APPLICATION FOR MAJOR SITE PLAN REVIEW

APPLICATION #: SPR26-0023
APPLICANT: Toledo Lucas County Port Authority
OWNER: Board of Lucas County Commissioners
LOCATION: 114 N. 13th Street
ZONING: Regional Commercial (CR)
NEIGHBORHOOD: Downtown
REPORT DATE: June 26, 2026
HEARING DATE: July 9, 2026
STAFF REVIEWER: Karcher

Proposed Landscape Plan:

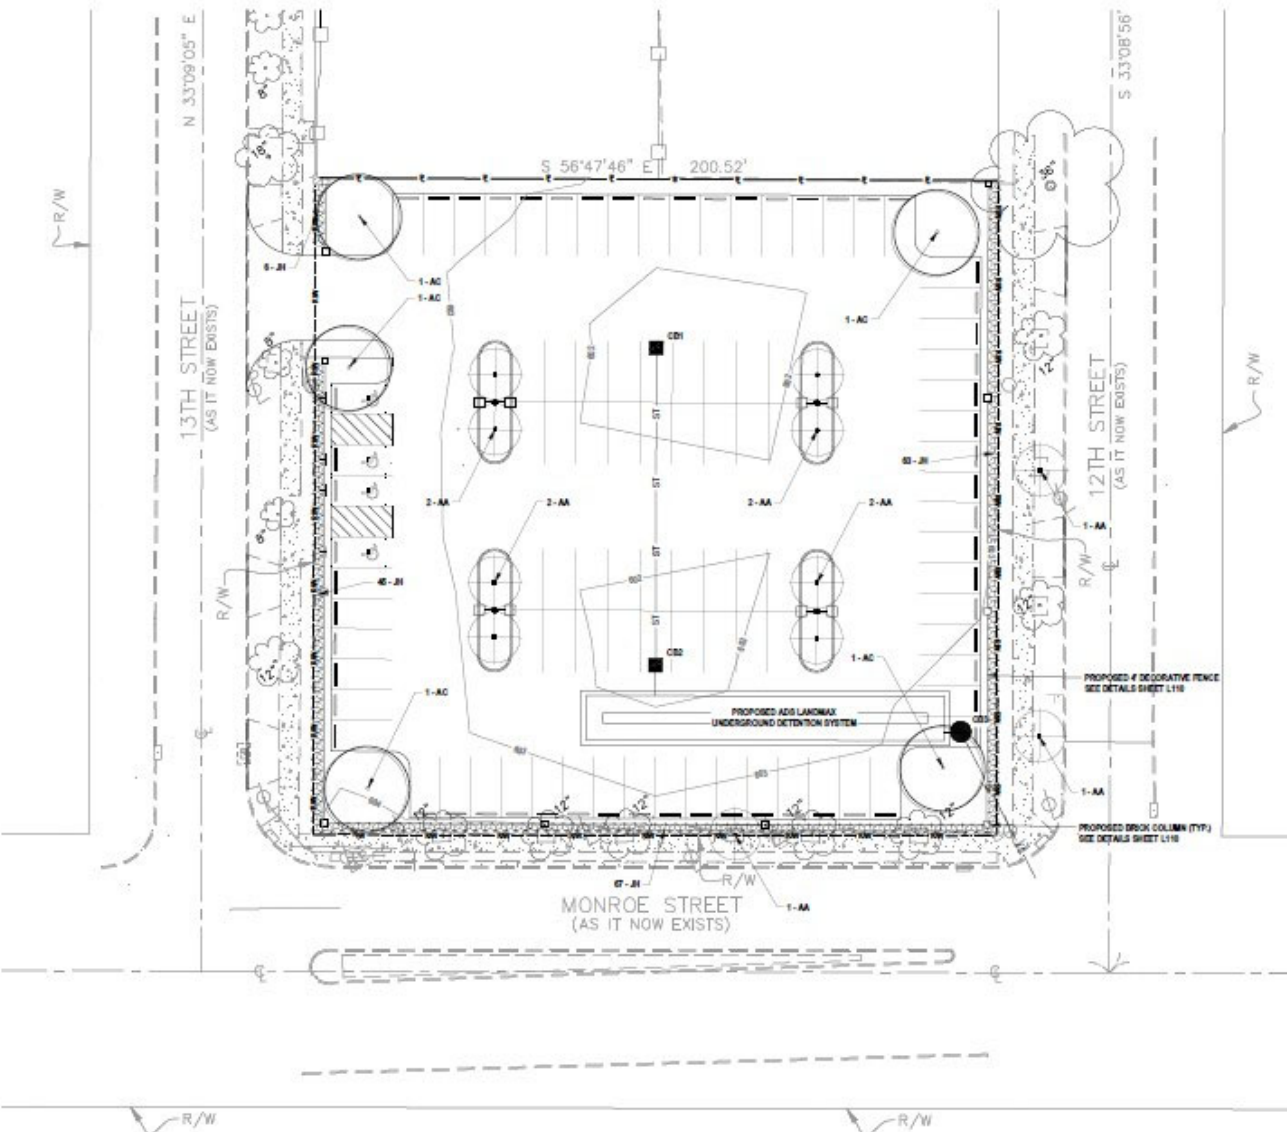
- (a) *Parking Lot Landscaping (TMC§1108.0305)*. Perimeter landscaping is required along 12th, 13th and Monroe Streets. The site plan depicts a landscaped area along these frontages that includes a forty-two inch (42”) tall high-strength aluminum alloy fence with brick columns. A row of shrubs is also proposed on the outside of the fence. While this meets the requirements of this section, the fence does not meet the height requirement of the Downtown Overlay District which is forty-eight inches (48”). In addition, the proposed shrubs are low growing. The purpose of the shrubs is to shield vehicle headlights from adjacent roadways; therefore, a shrub with a mature height of at least thirty-six inches (36”) is required – Not Acceptable. The proposed fence shall meet the Downtown Overlay District Standards in TMC§1103.0207 Special Design Standards - Surface Parking Lots and an appropriately sized shrub provided.

- b. Perimeter landscaping is required along 12th, 13th and Monroe Streets per TMC§1108.0305. The proposed forty-two inch (42") tall fence does not meet the height requirement of the Downtown Overlay District, which requires the fence to be forty-eight inches (48") in height. The proposed shrubs also do not meet the required mature height in order to shield vehicle headlights from adjacent roadways. A revised landscape plan shall be submitted depicting compliance with these requirements.
